www.mpja.com		
Title 5050 x 8 RGB LED Board		
Size	Document Number 36805-MP	Rev. B
Date 4/23	Sheet

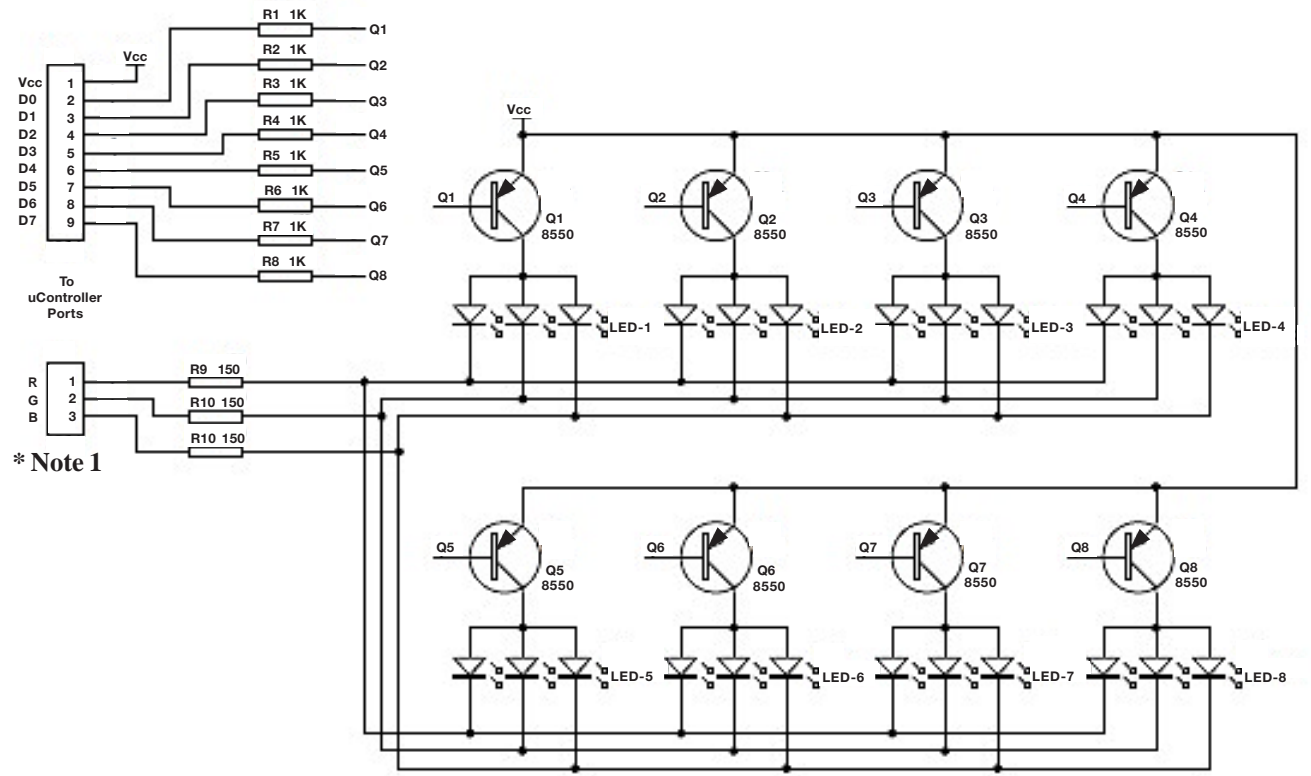
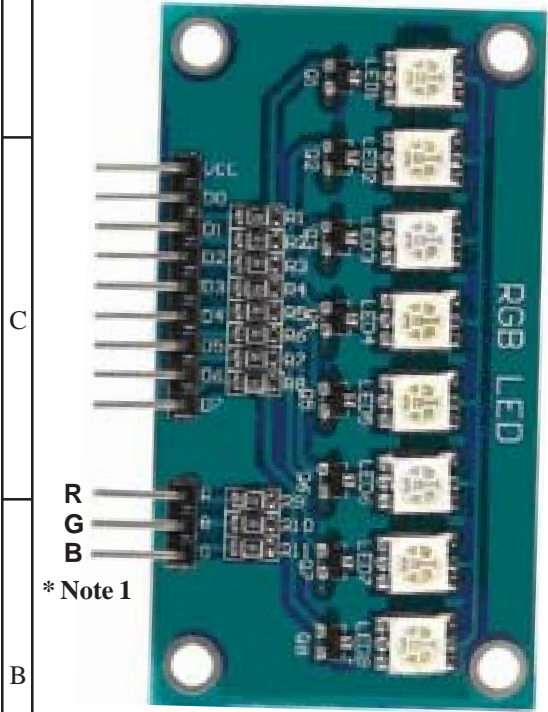
NOTE 1: Silkscreen of 3 Pin “RGB” Connector on Board is Incorrect! Above Picture and Schematic Shows Correction.
